# TECHNICAL BULLETIN

## RANGE EXTENDER MODIFICATION

MD-900 helicopters, serial number 900-00010 thru 900-00082.

Range Extender P/N 900P3661206-103.

**Figure 1. Range Extender Modification**

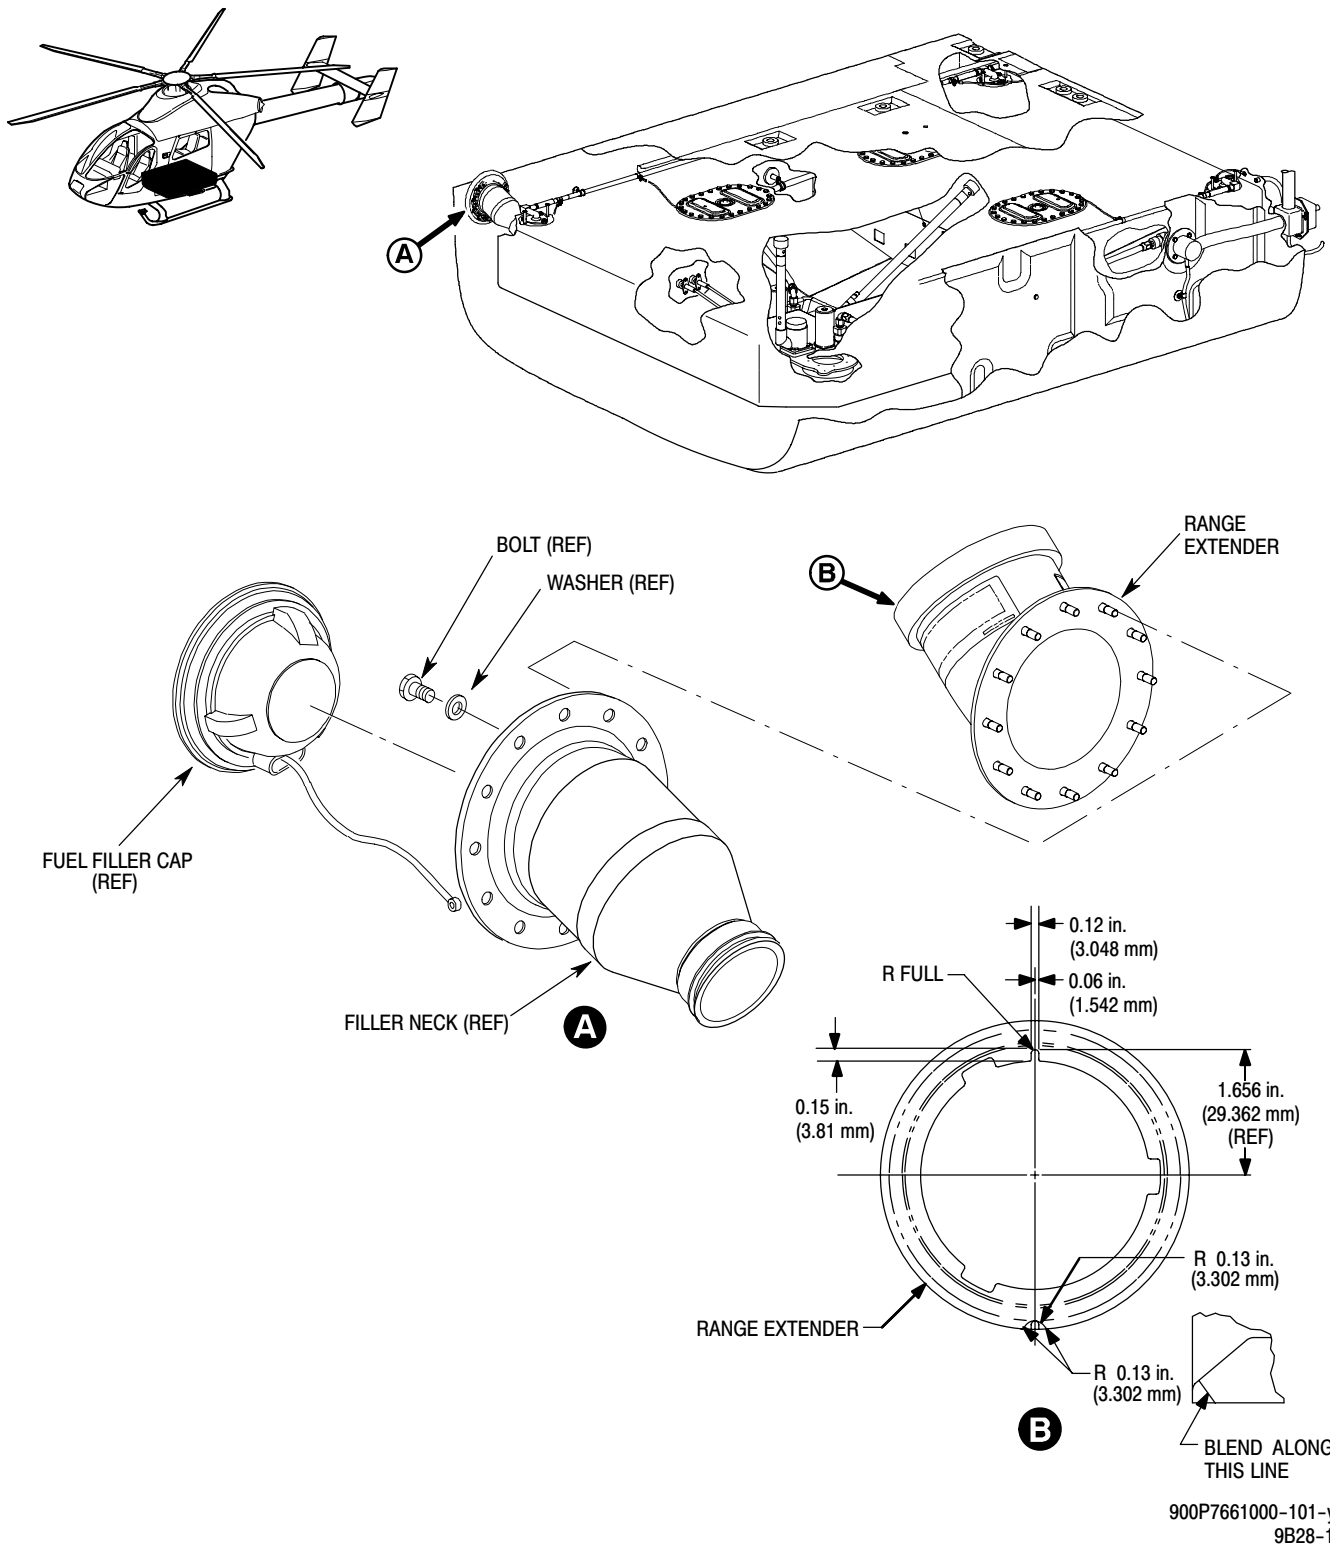
The notch on the 900P3661206-103 range extender, used to secure the flapper valve chain, frequently breaks the chain and the position of the notch places the chain across the neck opening, blocking it during fueling.

Procedures in this Bulletin provide owners and operators with information pertaining to modifying the range extender by blending the existing notch and adding a new notch on the top inner flange.

- (1). Blend existing notch with 0.13 inch (3.302 mm) radius normal to notch face, as shown.
- (2). Add new notch to dimensions shown.
- (3). Apply chemical coating to reworked areas per manufacturer's instructions.
- (4). Ink stamp new part number, 900P3661206-105, on modified range extender.
